AGENDA PLANNING COMMISSION MEETING

April 19, 2016

**PLANNING COMMISSION
 STAFF REPORT
 AGENDA ITEM NO. 5.A.
 April 19, 2016**

Request for a Planned Development Permit PDP-15-002, Use Permit UP-15-006, Architecture Review Permit AR-15-002 to allow the construction of five-story, 69'-4" high, 152-room hotel, with 3,000 square feet of meeting/banquet space and below grade parking pursuant to Chapters 12.96.190, 12.96.200, 12.84.210, and 12.108.010 of the San Bruno Municipal Code. OTO Development, LLC (Applicant).

West (REAR) Elevation
Scale: 3/32" = 1'-0"

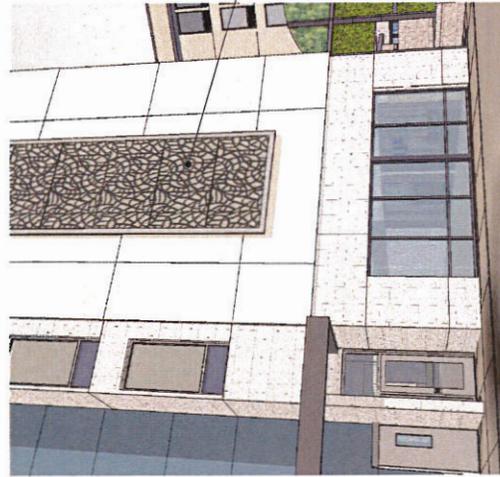
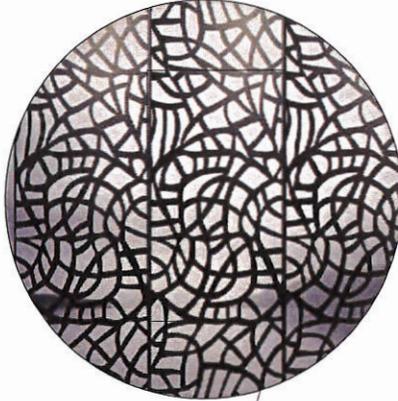
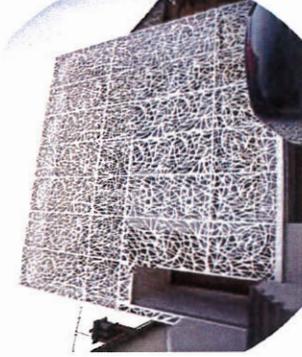
- Light standard fixture “Premier II” (Option 3) was selected as depicted in Exhibit I.
- The revised landscape plan as proposed dated 12/02/15 and the rendering of the east elevation is satisfactory.
- West elevation: propose a textured surface, or multiple textured surfaces, with a possible wave design, and consider extending it above the roof line. Provide a rendering for the Planning Commission meeting.
- Roof overhangs - not needed on the west elevation.
- Porte cochere - may have additional columns if structurally necessary, can be approved at staff level as part of the building plan review.
- Provide before and after elevations renderings with landscaping for review at the Planning Commission meeting.

In response to the ARC recommendations, revised plans were submitted dated January 5, 2016 with a new proposed West elevation detail for the Planning Commission consideration. It consists of two prefabricated framed vertical perforated panels from the second floor and extending above the parapet wall. The final pattern is to be determined and the proposed example is shown on Sheet DR-6A of the plans. The Committee’s recommendations were addressed and revised plans submitted and attached as Exhibit M.
